SUBJECT: Letter Solicitation SPRTA1-25-R-0289

CLIN	P/N	NSN	Noun	BEQ (Best Estimated Quantity)
0001	624864-3-1	1660-01-280-3132	CONTROL BOX, ELECTRI	20 EA

ENGINEERING ORDER					1. ENGINEERING ORDER NO. 2011C1412-T								
					DATE: 20111018	PAGE 1 OF 3 PAGES							
2. DWG TITLE CONTROLLER, FLOW TEMPERATURE				3. DWG CAGE CODE 07217		4. DWG NO. 624864

1. ENGINEERING ORDER NO.
2011C1412-T

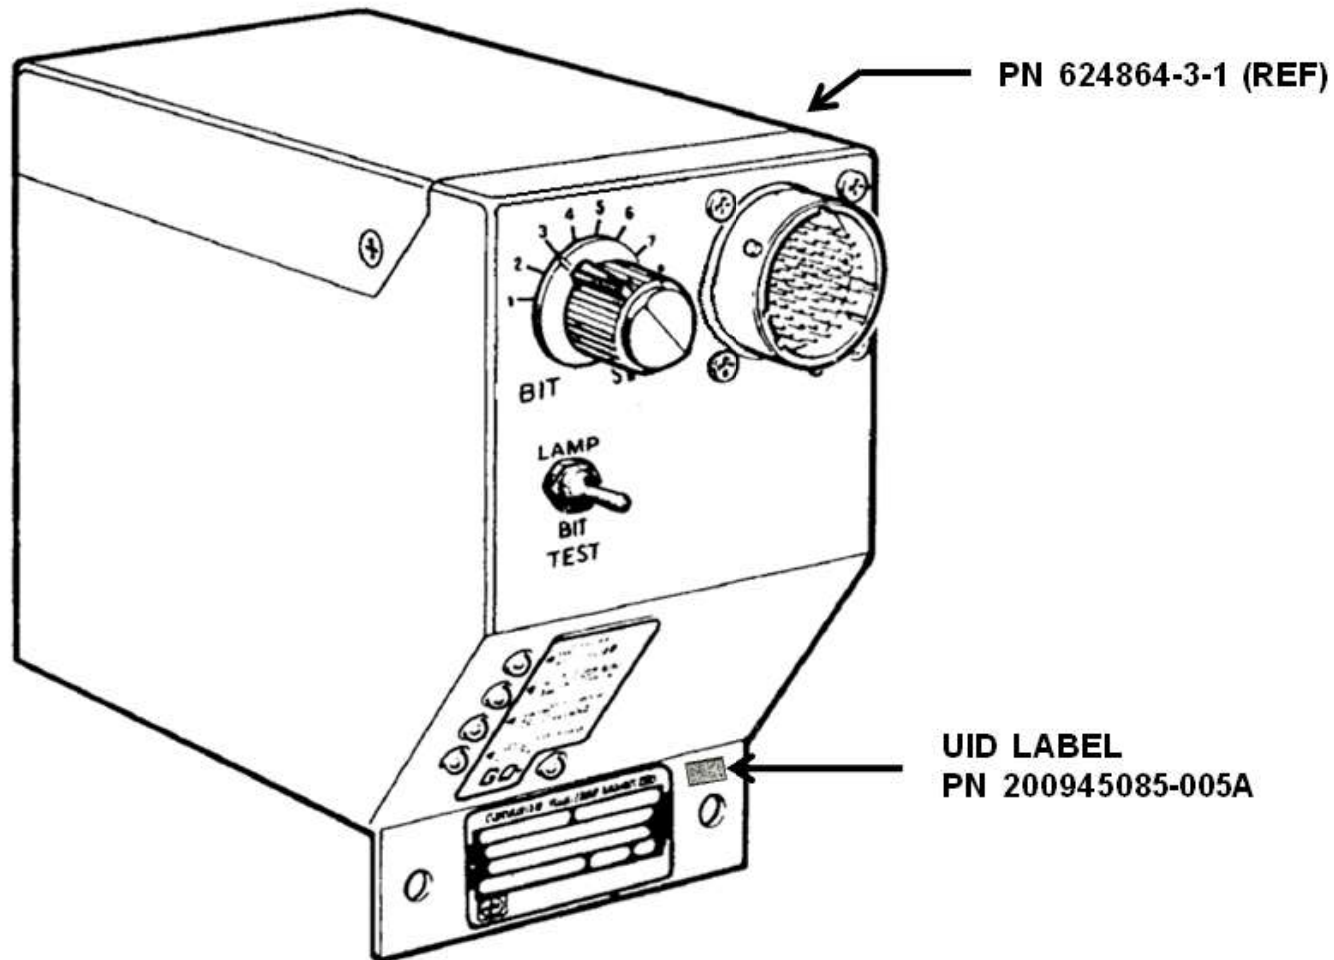
20. DESCRIPTION OF CHANGES/REMARKS													
- F-15 Aircraft Cabin Circuit Air Flow/Temperature Controller (PN 624864-3-1) shall be marked with a Unique Item Identifier (UII). (REF: MIL-STD-130) - If no UID label is present, fabricate new UID label (200945085-005A) and attach to the end item, adjacent to the existing identification plate/label (PN 1026454-3), - New UID label will be located on the end item as shown in sketch/photo on page 2, AF form 3926.
